Access Compliance Report

Public Rights-of-Way

(Curb Ramps)

Intersection ID: 6591	Main Street: PRAIRIE_VALLEY_DR	Cross Street: COCHRANE_DR	Location: W
ADA ID: 9C6058DC8F64	Ramp Type: BlendTrans1	Initial Pass/Fail: Fail	Overall Compliance: No
Severity Score: 35			
Codes/Mitigation Info/Possible Solution		Field Measurements/Component Compliance

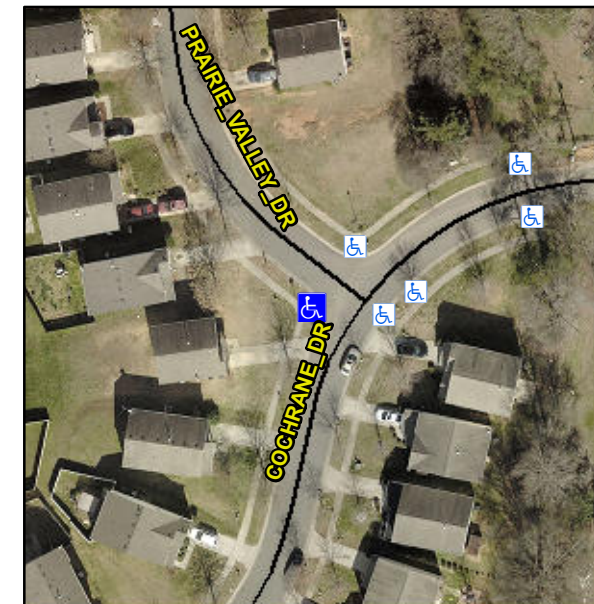
Not Found, R304.5.1

Compliance	Description	Data	Compliance	Description	Data
N/A	Ramp Length (in)	84.0	Yes	BlendTrans Slope (%)	3.1
No	Ramp Width (in)	27.0	Yes	BlendTrans XSlope (%)	1.9
N/A	Flare Type LT	N/A	N/A	Flare Type RT	N/A
N/A	Flare Slope LT (%)	N/A	N/A	Flare Slope RT (%)	N/A
N/A	Flare Traversable LT?	N/A	N/A	Flare Traversable RT?	N/A
N/A	Landing Length (in)	N/A	N/A	DWS Provided?	N/A
N/A	Landing Width (in)	N/A	N/A	DWS Contrast?	N/A
N/A	Landing Slope (%)	N/A	N/A	DWS Length (in)	N/A
N/A	Landing X Slope (%)	N/A	N/A	DWS Full Width?	N/A
N/A	Landing Curb? (Y/N)	N/A	N/A	DWS Offset (in)	N/A
N/A	Shared Landing?	N/A			
N/A	Gutter Ponding?	N/A	N/A	Gutter Slope (%)	N/A
N/A	Gutter Lip Ht (in)	N/A	N/A	Gutter X Slope (%)	N/A
N/A	Painted X Walk1?	No	N/A	Painted X Walk2?	No
	X Walk 1 Direction	To SE		X Walk 2 Direction	To NE
	X Walk 1 Width (in)	N/A		X Walk 2 Width (in)	N/A
	X Walk 1 Slope (%)	2.5		X Walk 2 Slope (%)	7.8
	X Walk 1 X Slope (%)	1.5		X Walk 2 X Slope (%)	3.3

N/A	Ramp inside XWalk1?	N/A	N/A	Ramp inside XWalk2?	N/A
	Road Slope (%)	0.1		Clear Space?	N/A
	Road X Slope (%)	7.0	N/A	Clear Space to XWalk (in)	N/A
N/A	Any Obstructions?	N/A	N/A	Storm Grate/Utility Hazard?	N/A
	Obstruction Type			Storm Grate/Utility Type	
		N/A			N/A
			Yes	Surface Condition? (G/P)	Good
			No	Curb Slope (%)	7.9

Remove & Replace Curb Ramp With Two New Directional Ramps or Equivalent.
